Pure Water San Diego Morena Pump Station and Pipelines

Air Release Valve Vent Map – See attachment for a larger view of the map

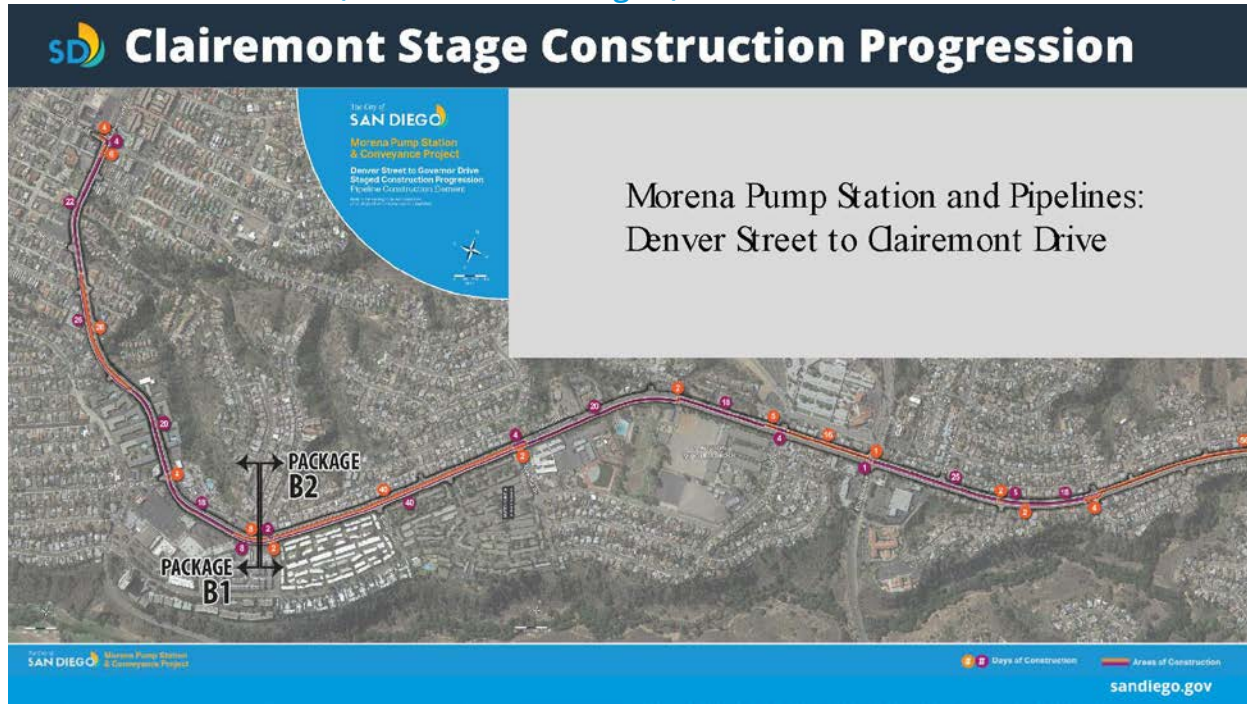
May we see a detailed map of the proposed pipeline route that includes the locations of tunneling, open trenching, and air release valves? This map should include which side of the streets the project will be constructed on.

The Final EIR includes graphics depicting the locations of the air valves and the work areas associated with open trenching and tunneling construction methods. The EIR also includes an analysis of potential odor. The High Purity Oxygen (HPO) and carbon canisters are odor mitigation disclosed in the EIR within the air quality section.

Morena Pump Station and Pipeline Map 1 – See attachment for a larger view of the map

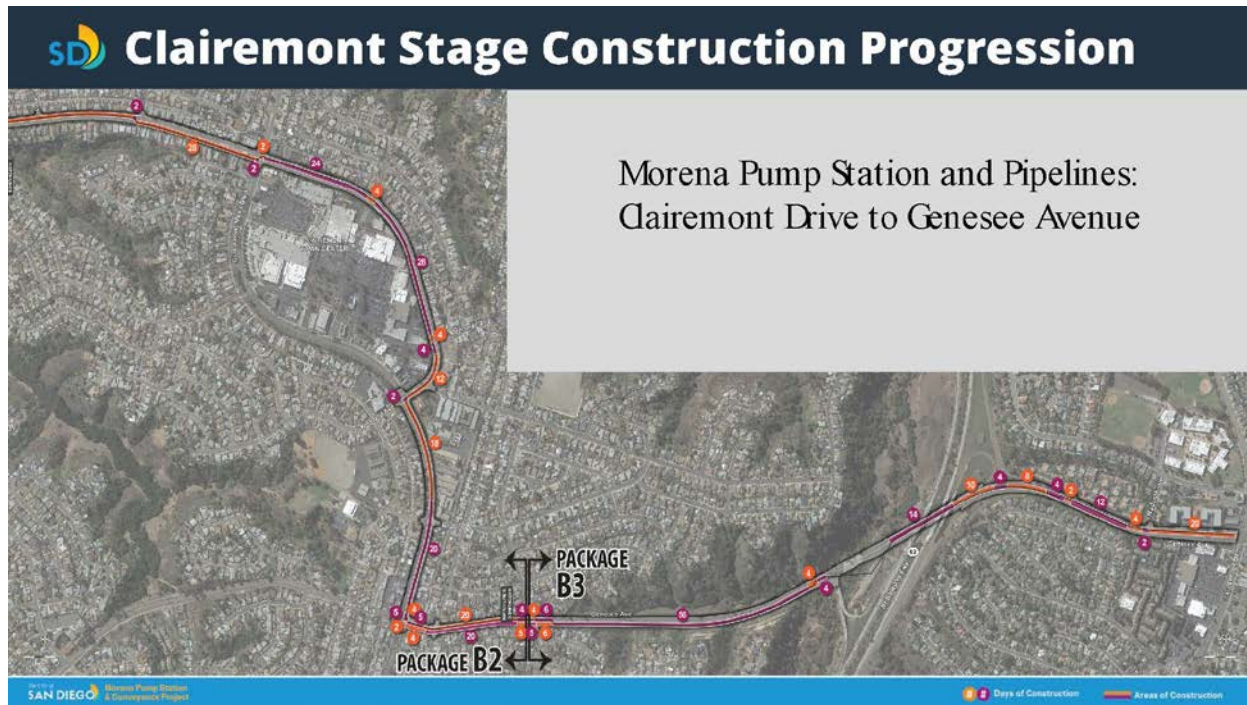
May we see a detailed map of the proposed pipeline route that includes the locations of tunneling, open trenching, and air release valves? This map should include which side of the streets the project will be constructed on. (Continued from Page 1)

The alignment maps below include estimated* time to complete specific segments of the pipeline. Please note the color variation to help identify segment lengths only. The City will be meeting with the working groups to further address concerns regarding pipeline construction impacts. In May 2017 an interactive map was launched on the Pure Water Program website detailing the location, status and purpose of each of the Phase 1 – North City projects. This page allows users to see an overlay of the proposed facilities on an interactive satellite imagery map. To view the projects, visit: purewatersd.org/phase1

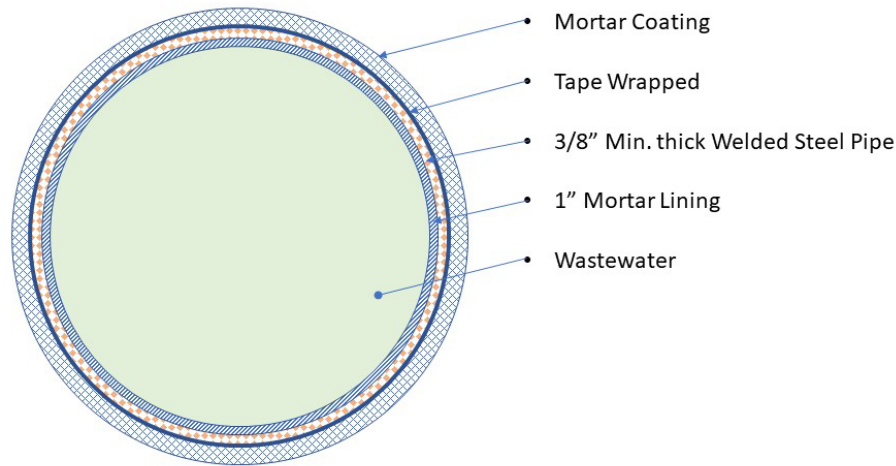
What preventatives are in place to stymie potential explosions/geysers of raw sewage?

In no scenario would an explosion or geyser occur, even in the event of a pipe break due to the fact this is a transmission pipeline between two facilities that is only pressurized at one location. A sudden change in pressure would cause the pump station to turn off and wastewater would cease to be pumped in the force main thereby depressurizing the pipe along the alignment.
